15 September 2015

Document No. 147645033-027-L-Rev0

ALLAWUNA FARM WORKS APPROVAL APPLICATION: W5830/2015/1 FURTHER INFORMATION

TITLE
**TYPICAL INTERPRETIVE SECTIONS
SHEET 1 OF 2**

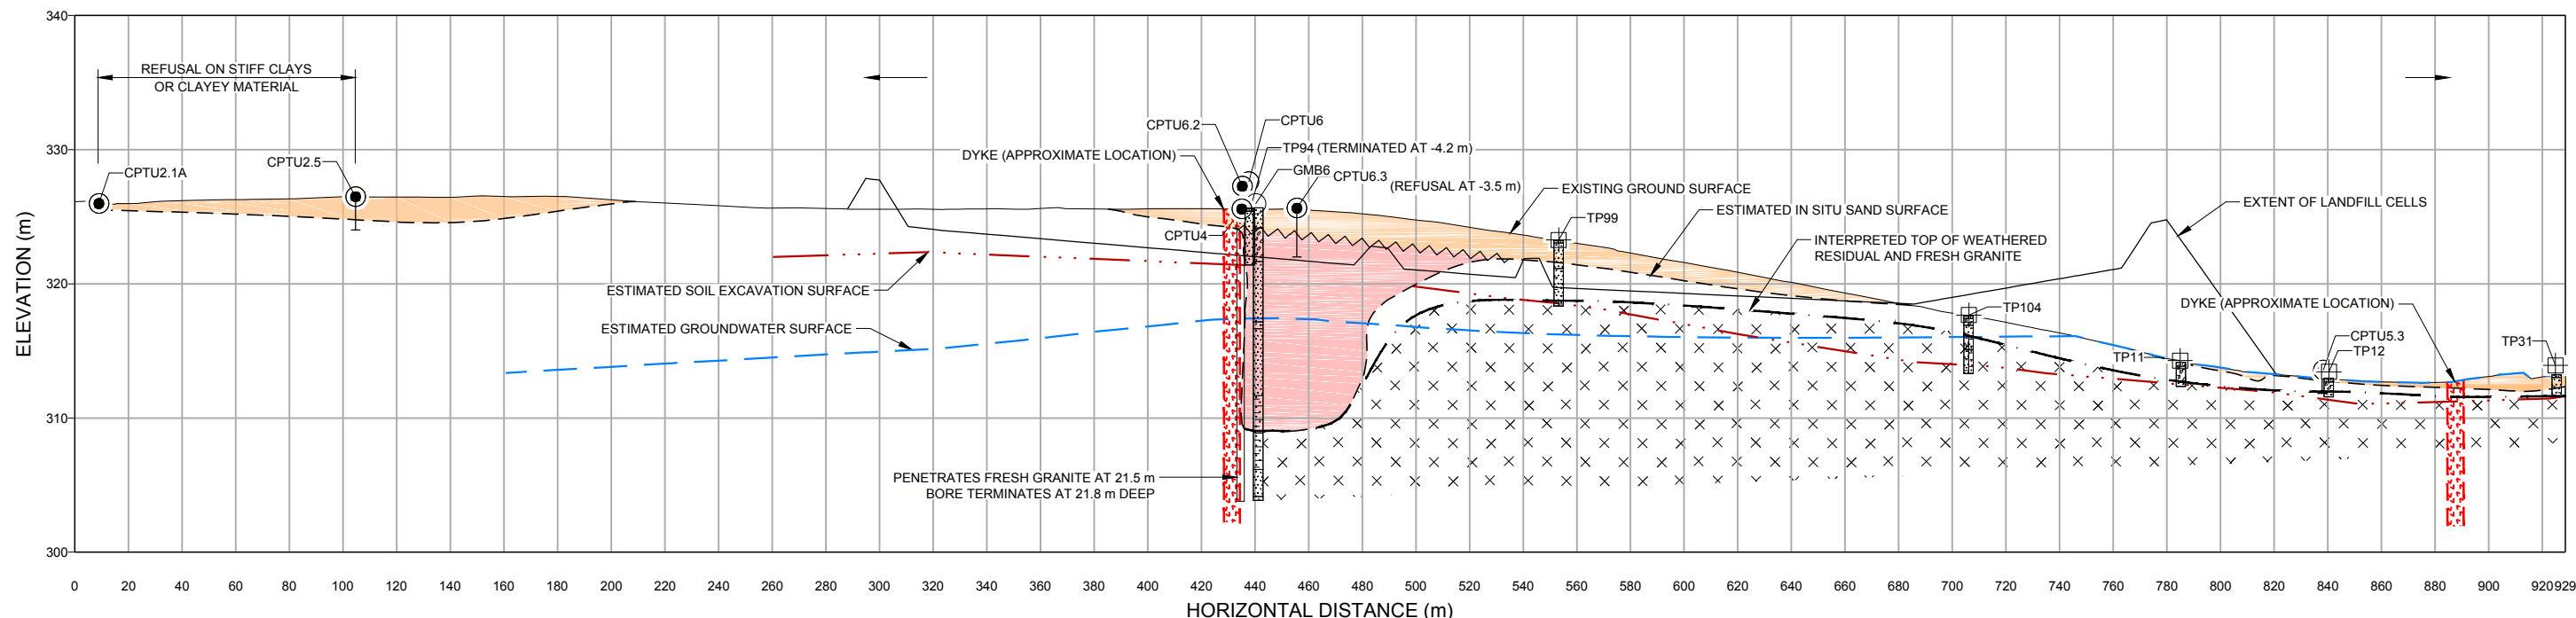
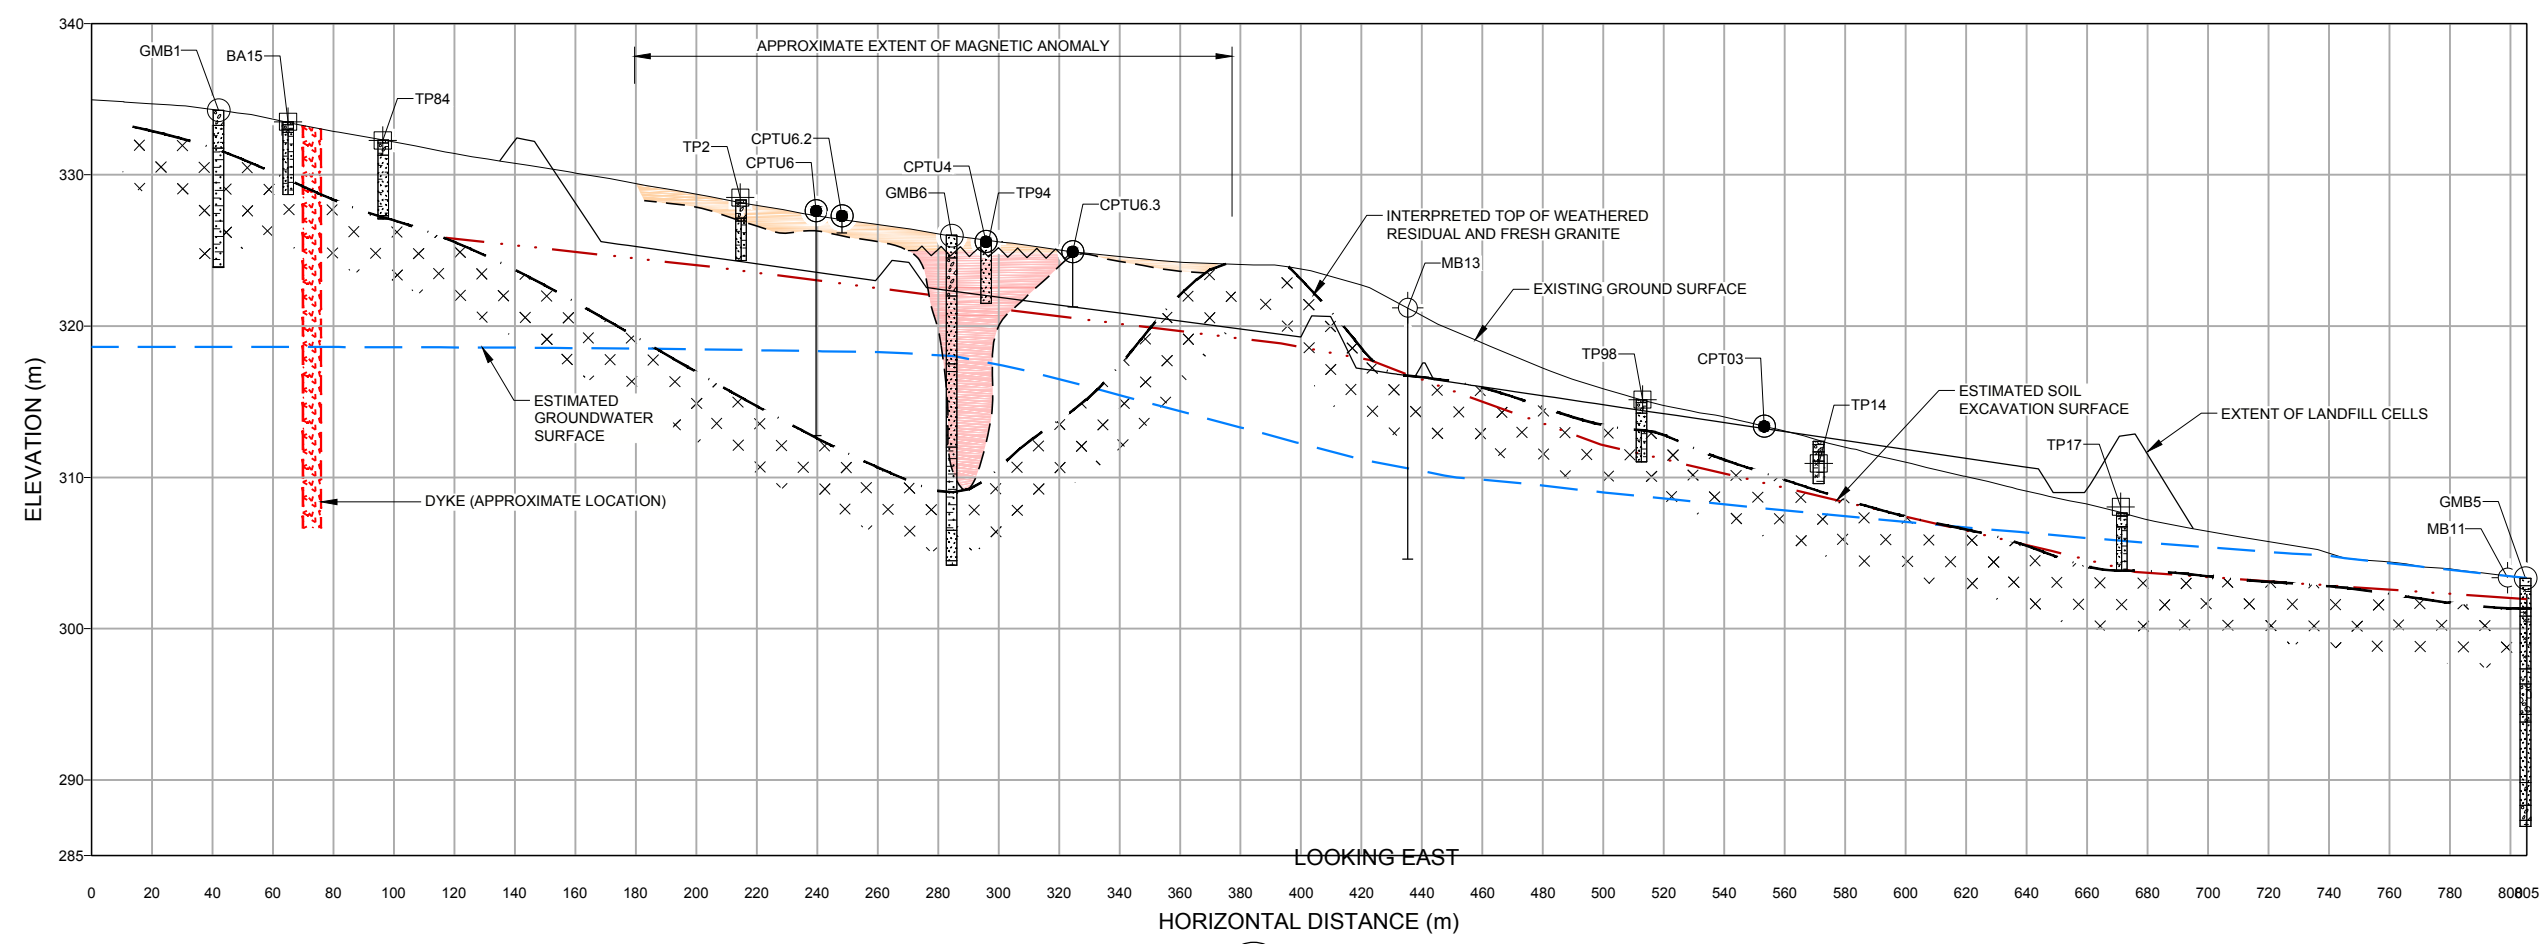
Lateral delineation of the above geological feature; if possible, determine extent and include an explanation of any geological end-points or barriers

Figure 3, Section B shows an interpretive cross section across the area of low magnetic intensity, the landfill (Cells 3, 2 and 1) and the area where sandy material was encountered at depth (test pit TP94 and borehole GMB6).

Figure 3, Section A shows an interpretive cross section along the lateral extents of the magnetic anomaly. CPT tests were carried across the northern most extent of the surveyed anomaly, in the vicinity of GMB6 and TP94 and towards the southern extent of the anomaly in the vicinity of the downstream toe of the landfill. The depth of the CPTs at the northern extent of Section A varied between 0.4 m and 3.4 m prior to encountering refusal on stiff to very stiff clay.

Figure 3, Section A and the observations as described above identify that the geological end points towards the north of the sandier zone is formed by stiff to very stiff clayey materials, while to the south it is formed by bedrock. The sandy material encountered in TP94 and its vicinity is expected to be localised *in situ* weathered granite or valley fill (mass wasting) materials that have not travelled very far from their source, surrounded by stiff to very stiff clayey materials.
